**SUBJECT: Wireless Telecommunications Facility Permit Application
(T-Mobile Site # LA33664E)**

SECOND NOTICE OF INCOMPLETENESS

Subject: Second Screencheck Comments - Wireless Telecommunication Facility Permit T-Mobile Site #LA33664E; W/O 10876 Culver Blvd

**ATTACHMENT 1
SECOND SCREENCHECK COMMENTS
WIRELESS TELECOMMUNICATION FACILITY PERMIT
T-MOBILE SITE #LA33664E – W/O 10876 CULVER BLVD**

EXHIBIT H1B

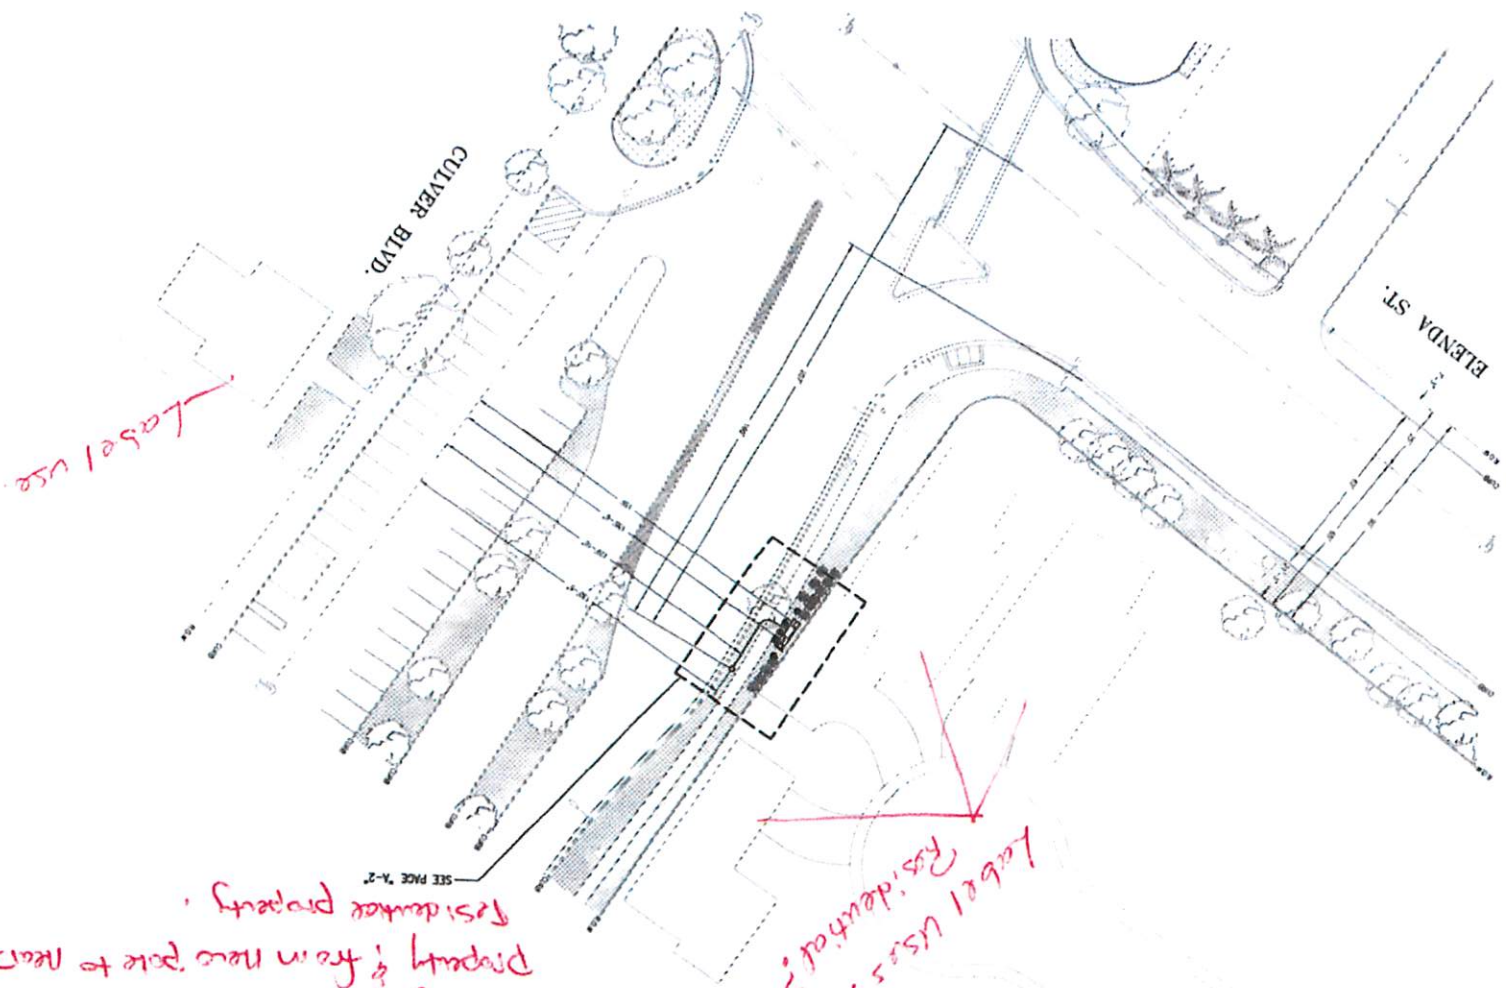
24. Provide a legend showing which sites are existing and which are proposed.

SHEET TITLE:
SITE PLAN
AND DETAILS
SHEET NUMBER:
A-1

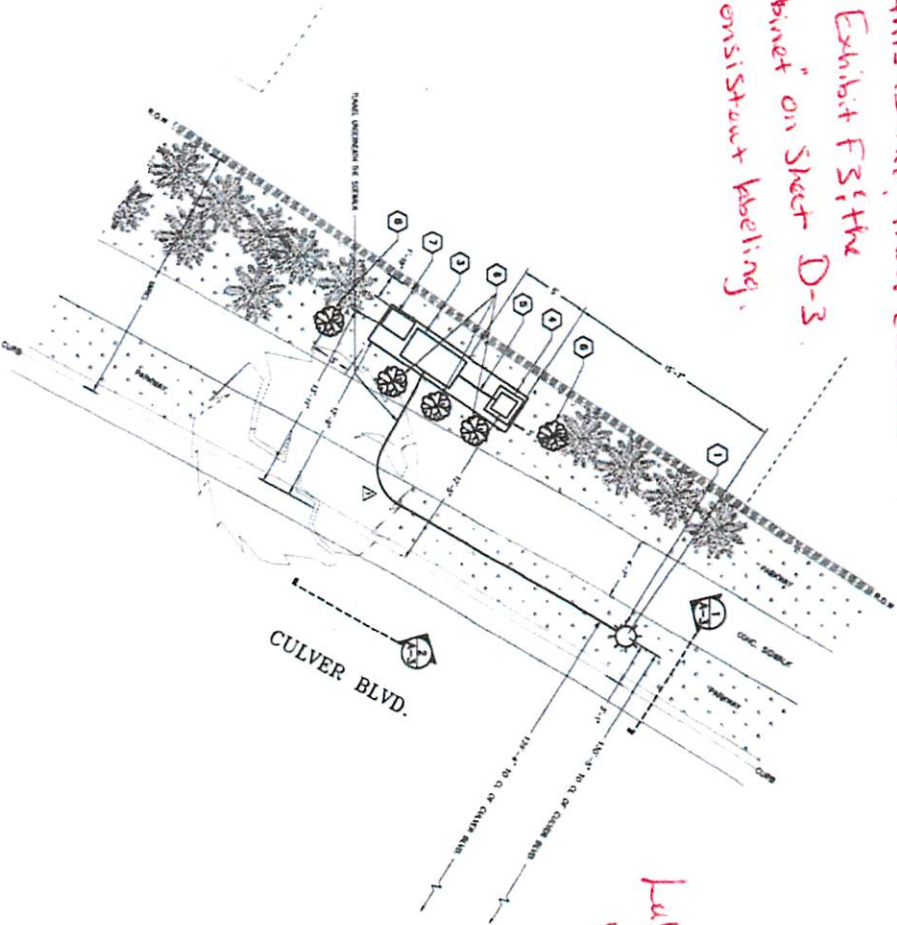
16. *2nd Request.* Label surrounding buildings and land uses. See redlined plans.

17. Show setback dimensions from the ground equipment to the nearest residential property and from the new pole to the nearest residential property. See redlined plans.

Dimension distance
from equipment to nearest residential
property & from new pole to nearest
residential property.

A-2

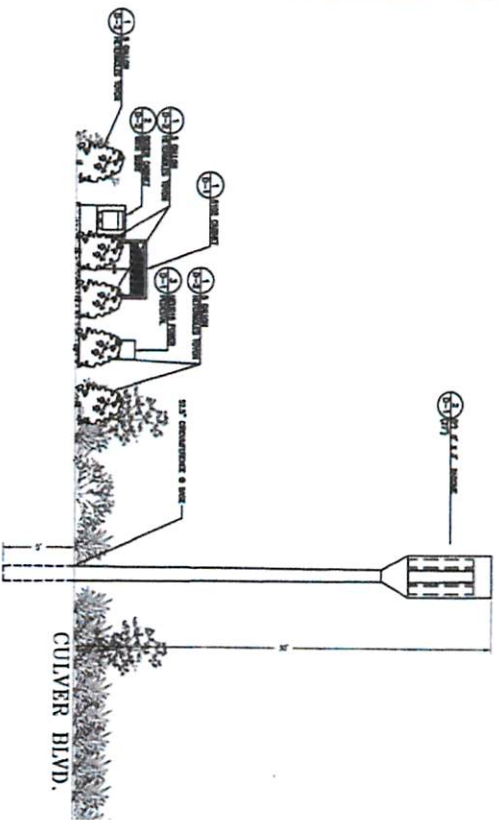
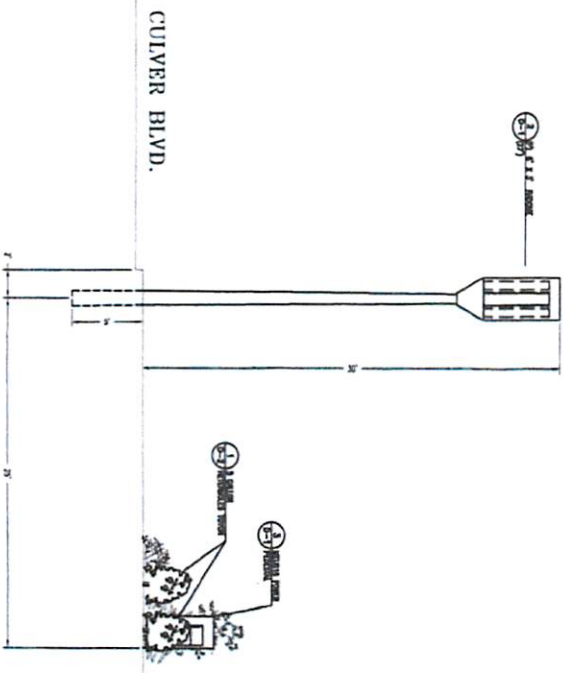
18. Label all existing utilities. See redlined plans.

19. Clarify if note #7 in the Placement and Construction Data section is referring to the same equipment as that which is referred to as the “fiber cabinet” shown on Exhibit F3 and the “boxer cabinet” shown on Sheet D-3 of the engineering plans. If so, provide consistent labeling in all exhibits.

Clarify if this is the "fiber cabinet" labeled in Exhibit F3; the "Boxer cabinet" on Sheet D-3. Provide consistent labeling.

Label any existing utilities.

SHEET NUMBER:
D-3

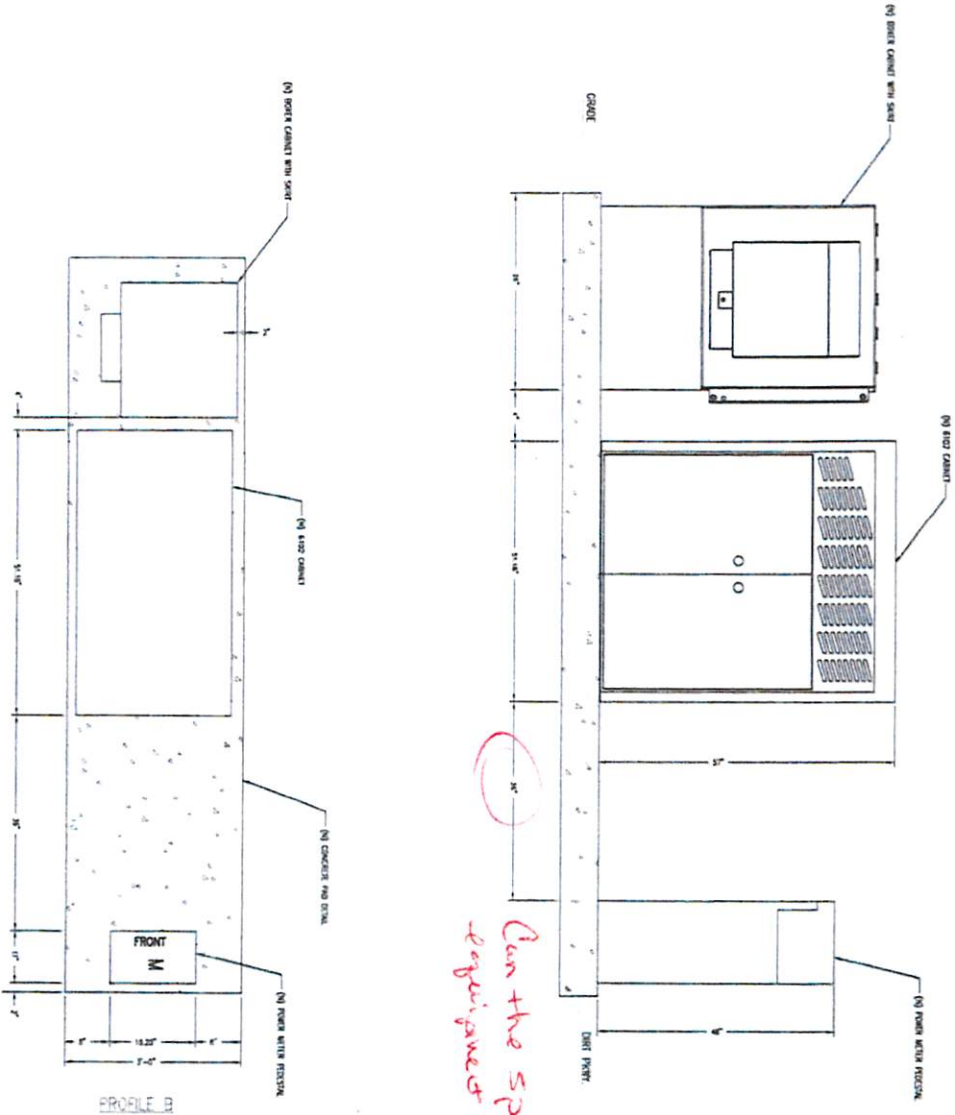
23. *2nd Request.* Decrease the size of the concrete pad to minimize the impact to the landscaped parkway. Provide clarification on why there needs to be so much space between the cabinet and the meter pedestal. See redlined plans.

Can the space between
equipment be minimized?
